Regulation No. 27 (Advance warning triangle)

Proposal for 04 series of amendments to Regulation No. 27 (Advance warning triangle)

Submitted by the experts from the Working Party "Brussels 1952"*

"Figure 2

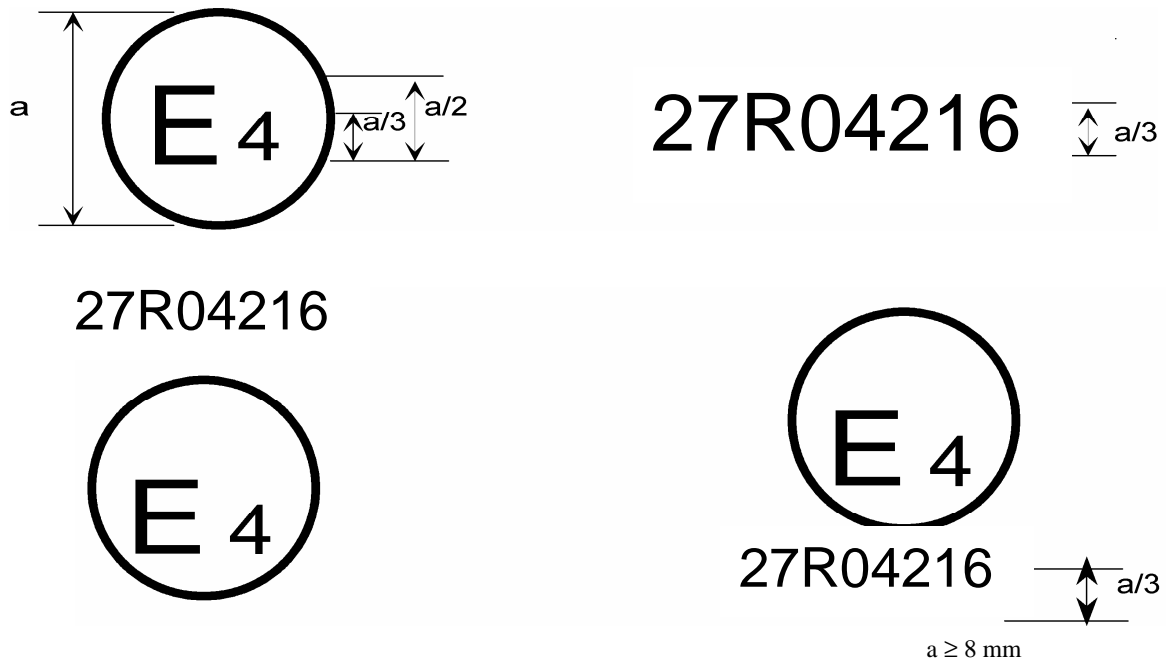
Annex 3, Figure 2, amend to read:

5. Finally, the test device for clearance to the ground in Annex 3 is simplified and only one dimension (300mm) will be applied.
 6. A transitional period of 36 months has been introduced into a new paragraph 14. to allow time for manufacturers and laboratories to adapt to the new measurement methods.
-

Arrangements of the approval marks

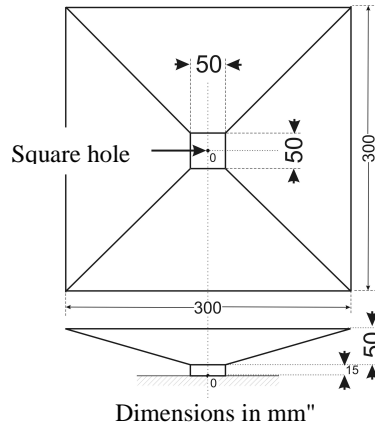
An advance-warning triangle bearing one of the approval marks shown above has been approved in the Netherlands (E4) under approval number **04216**. The first two digits of the

approval number indicate that the approval was granted according to the requirements of this Regulation as amended by the **04** series of amendments.
